# Access Compliance Report

## Public Rights-of-Way

### (Curb Ramps)

Intersection ID: 17548	Main Street: ROSWELL_AV	Cross Street: STERLING_RD	Location: NW
ADA ID: FC19921996B1	Ramp Type: PerpDiag	Initial Pass/Fail: Fail	Overall Compliance: No
		Severity Score: 22.5

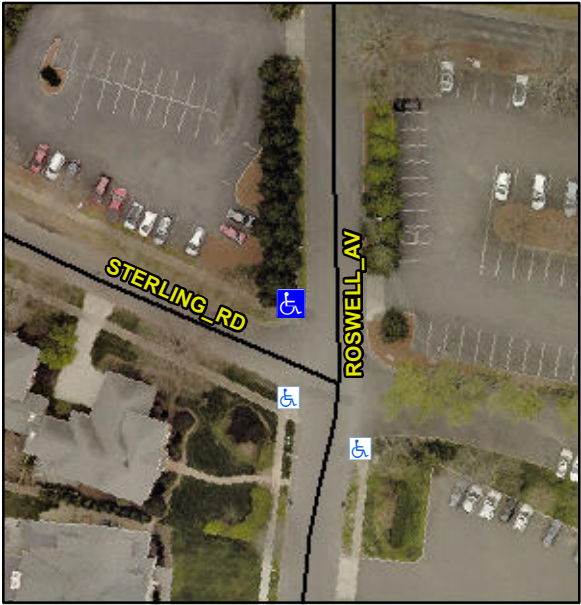
Codes/Mitigation Info/Possible Solution			Field Measurements/Component Compliance		
	Possible Solutions:		<b>Compliance</b>	<b>Description</b>	<b>Data</b>
	<b>Remove &amp; Replace Curb Ramp With Two New Directional Ramps or Equivalent.</b>		<b>No</b>	Ramp Length (in)	<b>69.0</b>
			<b>No</b>	Ramp Width (in)	<b>46.0</b>
			<b>N/A</b>	Flare Type LT	<b>N/A</b>
			<b>N/A</b>	Flare Slope LT (%)	<b>N/A</b>
			<b>N/A</b>	Flare Traversable LT?	<b>N/A</b>
			<b>N/A</b>	Landing Length (in)	<b>N/A</b>
			<b>N/A</b>	Landing Width (in)	<b>N/A</b>
			<b>N/A</b>	Landing Slope (%)	<b>N/A</b>
			<b>N/A</b>	Landing X Slope (%)	<b>N/A</b>
<p>Surveyor Notes:</p> <p><b>N/A</b></p> <p>PROW/ADA:</p> <p><b>Not Found, R304.5.1, R304.2.2, R304.5.3</b></p>			<b>N/A</b>	Flare Type RT	<b>N/A</b>
			<b>N/A</b>	Flare Slope RT (%)	<b>N/A</b>
			<b>N/A</b>	Flare Traversable RT?	<b>N/A</b>
			<b>N/A</b>	DWS Provided?	<b>N/A</b>
			<b>N/A</b>	DWS Contrast?	<b>N/A</b>

<b>N/A</b>	DWS Length (in)	<b>N/A</b>
			<b>N/A</b>	DWS Full Width?	<b>N/A</b>
			<b>N/A</b>	DWS Offset (in)	<b>N/A</b>
			<b>N/A</b>	Gutter Ponding?	<b>N/A</b>
			<b>N/A</b>	Gutter Lip Ht (in)	<b>1.0</b>
			<b>No</b>	Painted X Walk1?	<b>No</b>
				X Walk 1 Direction	<b>To S</b>
			<b>N/A</b>	X Walk 1 Width (in)	<b>N/A</b>
			<b>6.5</b>	X Walk 1 Slope (%)	<b>5.2</b>
			<b>0.9</b>	X Walk 1 X Slope (%)	<b>3.4</b>
			<b>N/A</b>	Ramp inside XWalk1?	<b>N/A</b>
			<b>5.9</b>	Road Slope (%)	<b>N/A</b>
			<b>4.8</b>	Road X Slope (%)	<b>N/A</b>
			<b>N/A</b>	Any Obstructions?	<b>N/A</b>
				Obstruction Type	
Total Cost: \$ 3200.00			<b>N/A</b>	Storm Grate/Utility Hazard?	<b>N/A</b>
			<b>N/A</b>	Storm Grate/Utility Type	
			<b>Yes</b>	Surface Condition? (G/P)	<b>Good</b>
